MCI, LTD. 3404 N. Holton Street, Milwaukee, Wisconsin 53212 414 962-0700

AIRBALL BLOWER CONTROL MODIFICATION

FIGURE 1 (Modified Unit) 10-12-73

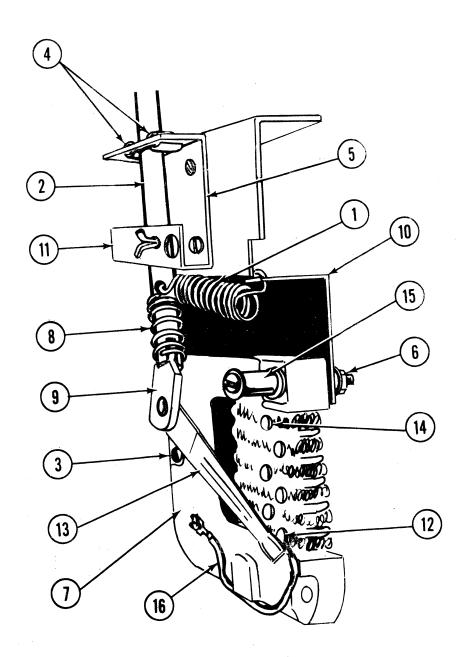
- 8. Install one flat washer onto the 4-40 x l 1/2" screw. Then install the 5/8" gray insulated spacer (15) and another flat washer. Install this assembly through the front mounting hole so that the wiper arm will be stopped by the insulated spacer. Add the other flat washer, the lock washer, and 4-40 nut as shown. Leave the 4-40 nut finger tight. Also loosen the 8-32 screw and nut (3) this will be tightened later.
- 9. Install the two 7/16" gray spacers with the cut (4) in upper slot of the blower handle mounting bracket (5) as shown.

10. With the 8-32 (3) and the 4-40 (6) loose, adjust the rheostat (7) to its furthest downward and forward position. Tighten the 8-32 (3) and the 4-40 (6). Note: Do not over tighten these nuts as excessive force will crack the rheostat body.

- 11. Re-install the assembly into the cabinet and tighten the two 7/16" blower assembly mounting nuts.
- 12. Install handle (2) from topside. As the handle passes through lower slot of blower handle mounting bracket (5), install 7/8" compression spring (8) around blower handle so that the slot in the handle straddles the tip of the fiber link (9) of the rheostat.

- 13. Now push the compression spring (8) down so that the blower handle return spring (1) can be installed on the blower handle Release the compression spring so it rests on the blower handle return spring and fiber link as shown.

- 14. Attach the other end of the blower handle return spring to the mounting bracket (10).
- 15. Install the new 3/16" x 1 1/2" cotter pin (11) through the upper hole in the blower handle. Spread the cotter pin.

- 16. Adjust the blower handle mounting bracket (5) so that the wiper in an "at rest" position is off the last contact rivet (12). When the blower control handle is pushed all the way forward, the wiper arm (13) should just be touching its furthest contact rivet (14). If additional adjustment is needed, loosen the rheostat mounting screws (3 & 6) and adjust rheostat to obtain desired wipe.

This modification will prevent damage to the fiber link in locations where excessive abuse is encountered.
